WestConnex M4-M5 Link

Rozelle Interchange - Modification: The Crescent overpass and active transport links

Design amendment report

April 2020

Figure 3-2: Traffic signal phasing on Johnston Street/The Crescent/Chapman Road intersection

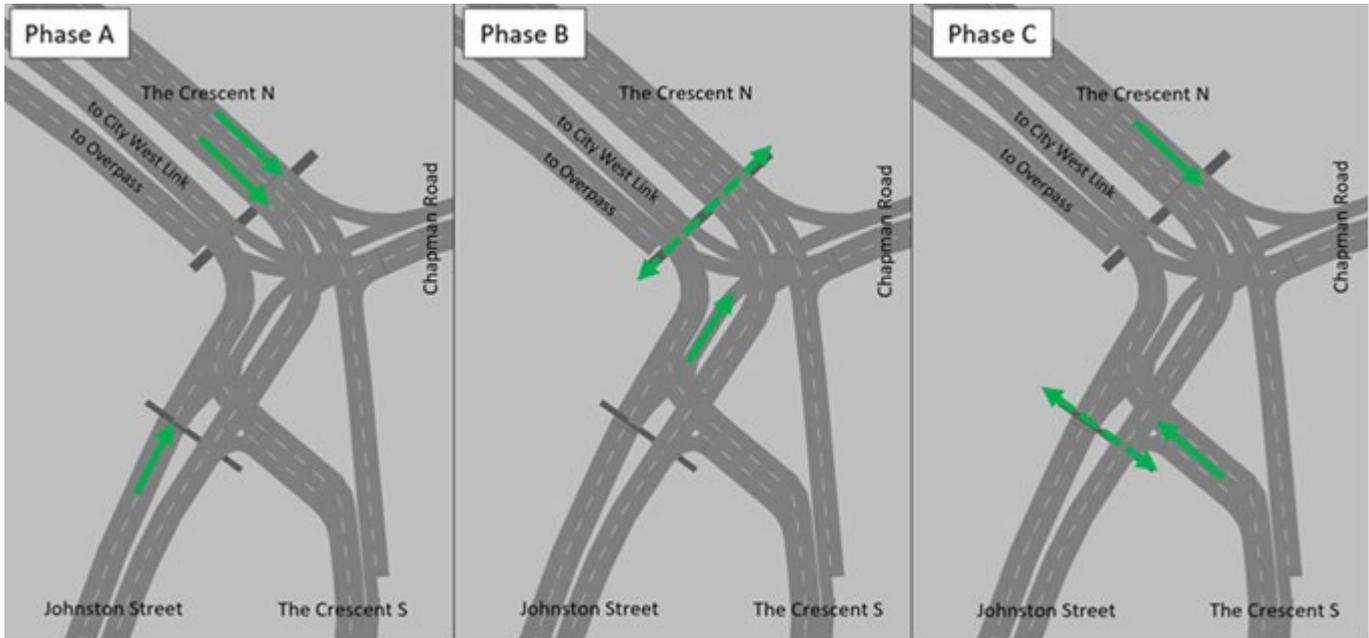
The traffic signal phasing used at The Crescent/Johnston Street/Chapman Road intersection is shown in **Figure 3-2**. The traffic signal cycle length used is 150 seconds.

The length of phase B is dictated by the length of the pedestrian crossing on the northern approach to the intersection and is fixed at 20 seconds minimum green time.

Figure 3-4: The Crescent mural

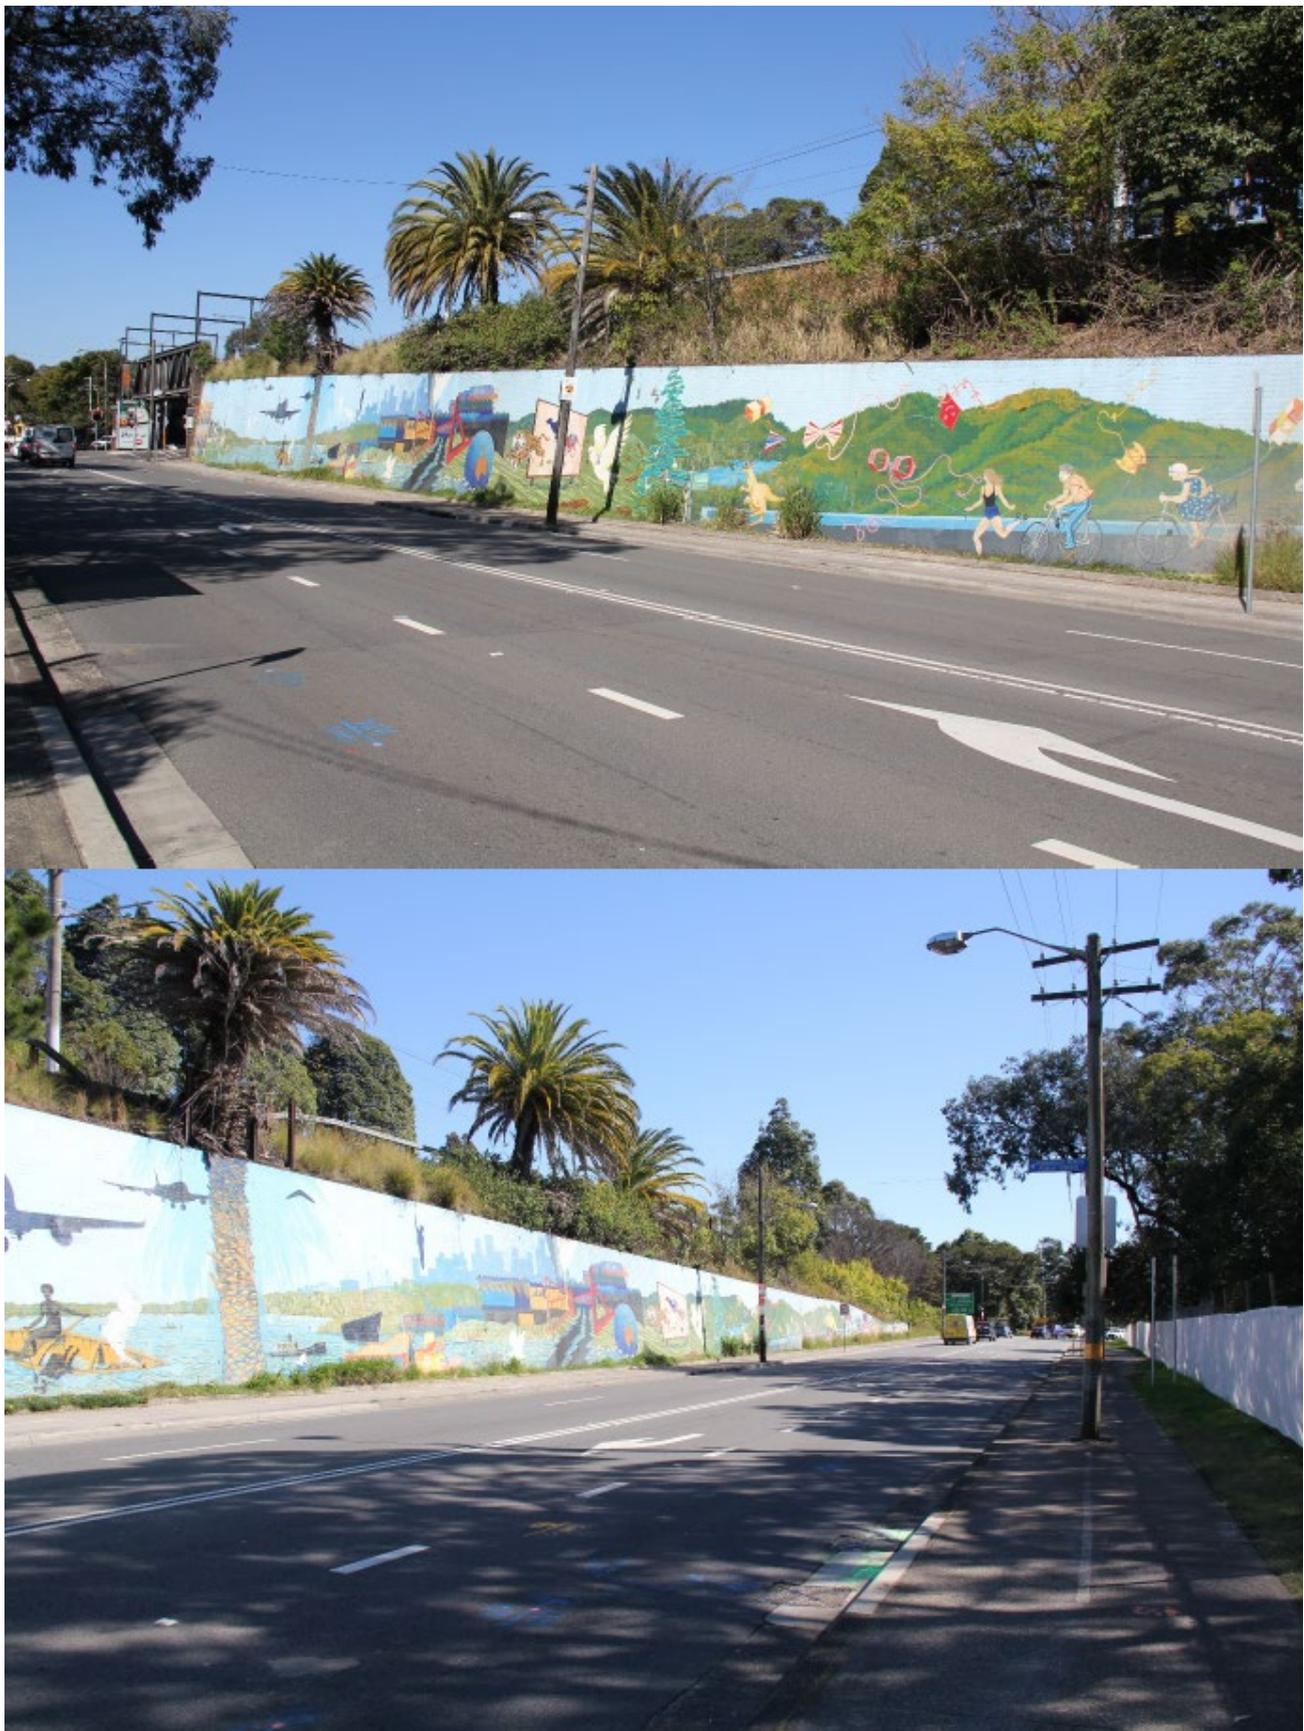
Along the west side of The Crescent the shared user path ramp and overpass would impact on views from motorists, pedestrians and cyclists toward the northern section of the existing mural, however, views to the central and southern sections of the mural would not be impacted. In the EIS there was a pedestrian ramp proposed in this same location which would have a similar impact on views to the mural. New views of the mural would be created for pedestrians and cyclists using the shared user path ramp. Photos of the existing mural are shown in **Figure 3-4**.
